Submission in relation to North West Rail Link – Environmental Impact Statement Stage 2 – Stations, Rail Infrastructure and Systems

This submission is made by Lend Lease GPT (Rouse Hill) Pty Ltd as the developer of The New Rouse Hill residential project, as part of the greater Rouse Hill Regional Centre development. The proposed North West Rail Link corridor runs adjacent to our project boundary between Sanctuary Drive and White Hart Drive.

Bus Layover – End State Designs (Overlay)

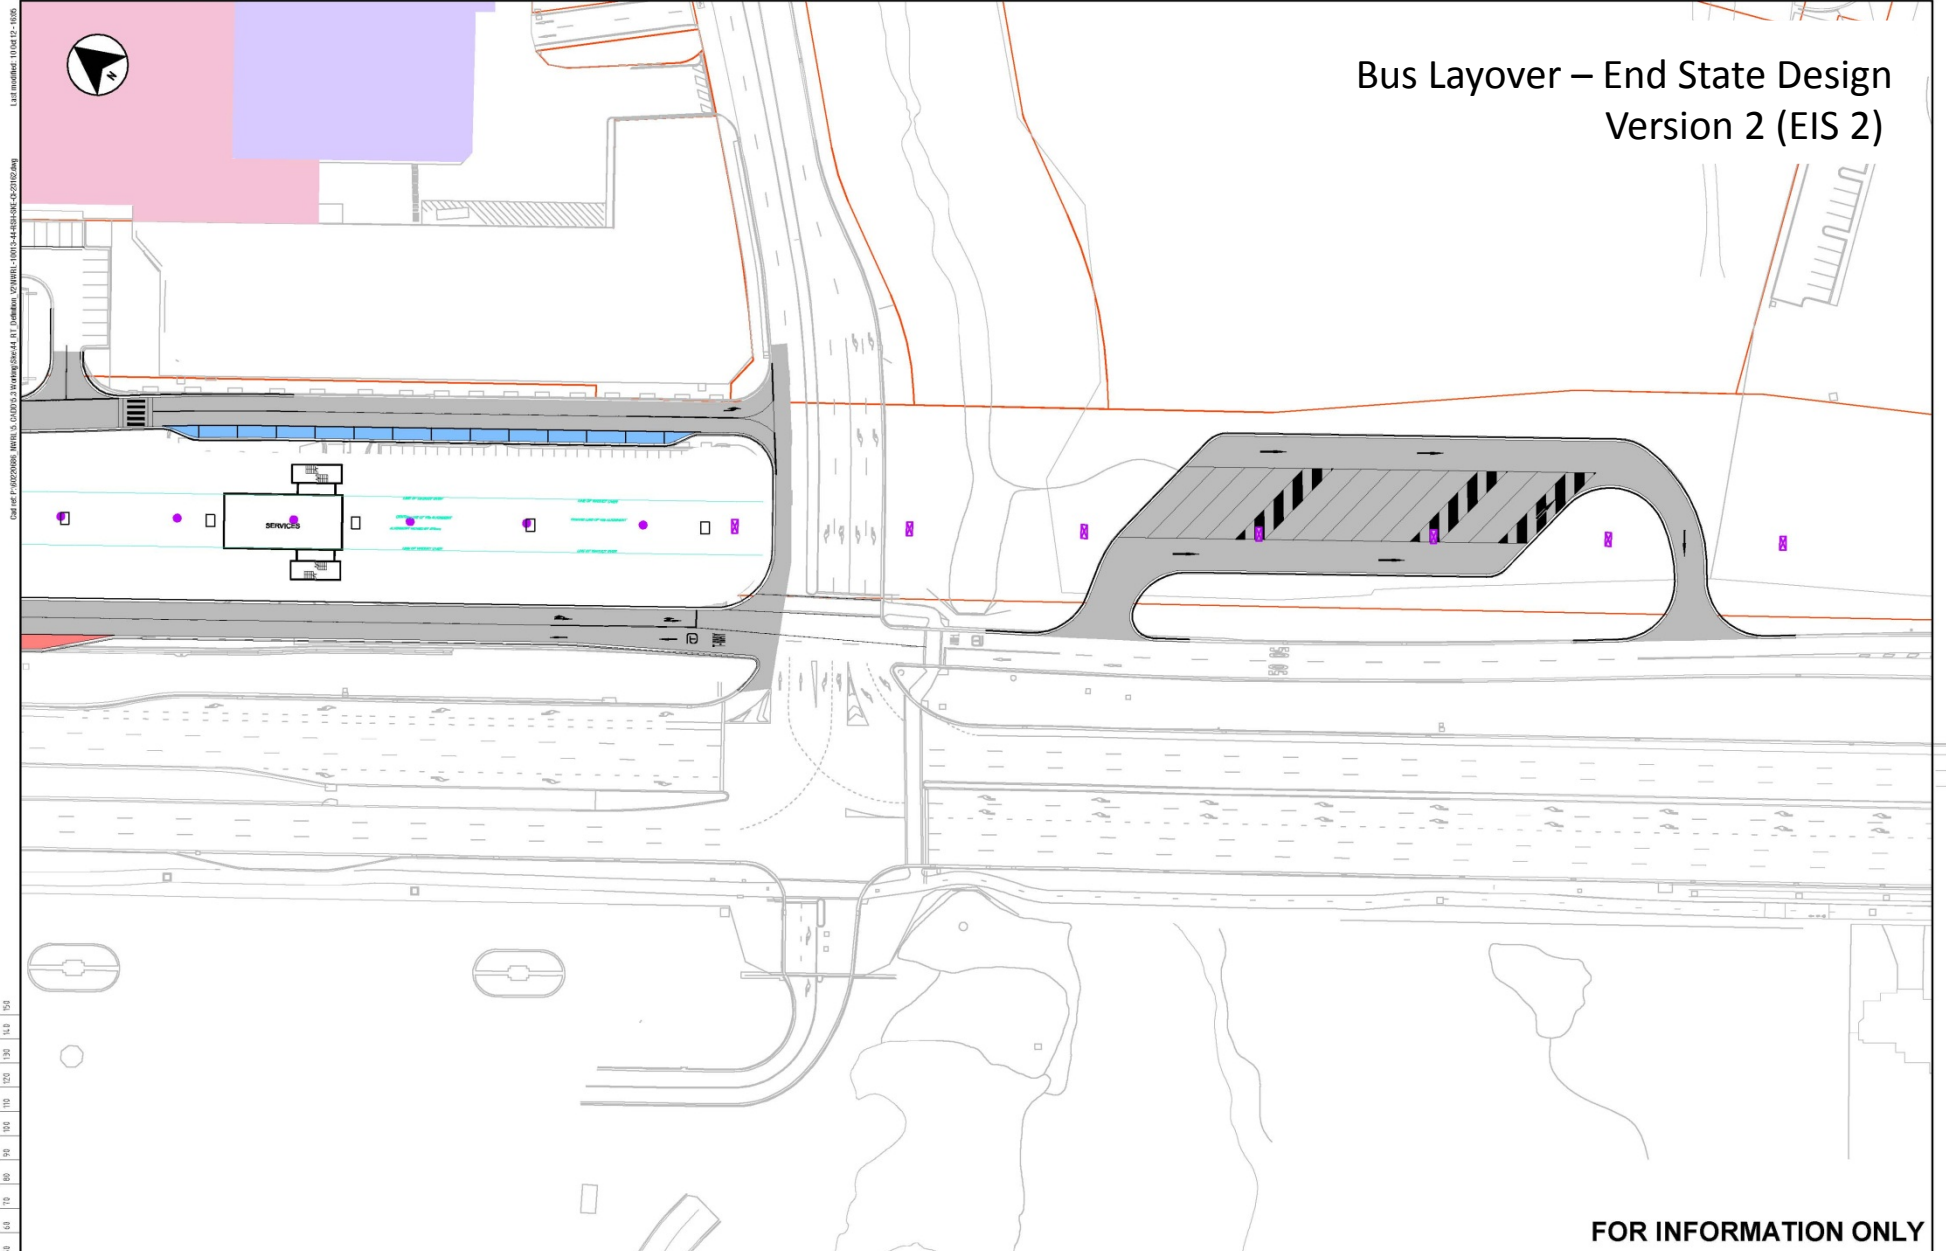
This design creates an edge almost on the corridor boundary adjacent to Rouse Hill Regional Centre land planned for residential or mixed use development. This outcome has two negative implications that should be addressed in design by generally moving the layover to the west:

- The ability to create through access in the corridor for pedestrians and bike riders is greatly limited by this approach and inconsistent with DGRs 40 and 41. Earlier comments by Transport NSW (commenting on the precinct design for development immediately to the east known as the Central Precinct) requested that strong pedestrian and bike links be established through this area to reinforce sustainable transport outcomes connecting to the future Rouse Hill Station. Furthermore, by locking out pedestrian and bike riding activity, there is a likelihood that a dead activity zone is created in this area inconsistent with crime prevention through design standards

- Location of the layover this close to the corridor boundary limits the ability to place sufficient trees as part of the wider landscape strategy put forward in the EIS to help mitigate visual impacts of the viaduct. Further, the visual impact of the layover facility itself will be a negative outcome for residents adjacent to the facility.

Reduced direct pedestrian and cycling link to station

Reduced screening opportunities

Recommendation: As the bus movements into the layover are only from the north the entry road angle to the layover can be relaxed allowing the main body of the layover to shift west. This design adjustment would allow for sufficient pedestrian and bike thoroughfare together with improved landscape outcomes.
